Re: Response to TIS Comments
Hudson Logistics Center
Hudson, NH
Langan Project No.: 151010101

Below are the applicant's responses to comments made in an Intra-Department Communication from John Butler to Brian Desfosses, dated October 2, 2020. Below please find each comment followed by our response in ***bold and italics***.

Figure 3B-11. Examples of Applications of Conventional Road Lane-Drop Markings (Sheet 1 of 2)

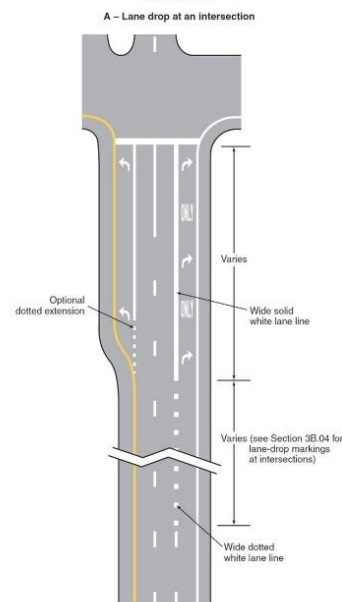
3. The proposed geometry along NH 3A results in three "trap" lanes (where a through lane becomes an exclusive turning lane):
- Northbound through lane at Walmart Boulevard becomes an exclusive left turn lane at Sagamore Bridge Road
 - Southbound through lane at Walmart Boulevard becomes an exclusive right turn lane at Green Meadow Drive
 - Southbound through lane at Green Meadow Drive becomes an exclusive left turn lane at Dracut Road.

Trap lanes are undesirable from a safety perspective. The consultant should investigate ways to eliminate the trap lane geometry. If this is not feasible, measures to mitigate the safety concern should be presented.

Southbound through lane at Walmart Boulevard becomes an exclusive right turn lane at Green Meadow Drive. There is not enough room between Walmart Boulevard and Green Meadow Drive to drop the through lane prior to developing an exclusive right turn lane. However, there is enough room to provide advance signing and marking according to Figure 3B-11 A – Lane Drop at an

intersection. The design involves a wide dotted lane line and a sign indicating two through lanes, a right turn only lane and a left turn only lane ahead. In addition, an attempt will be made to provide a traffic island on the Green Meadow approach that will further alert southbound motorists of the right turn only lane ahead. Southbound through lane at Green Meadow Drive becomes an exclusive left turn at Dracut Road. The roadway curvature between Green Meadow Drive and Dracut Road may facilitate restriping the Lowell Road to appropriately drop the outside through lane and develop two left turn lanes off the continuous inside through lane.
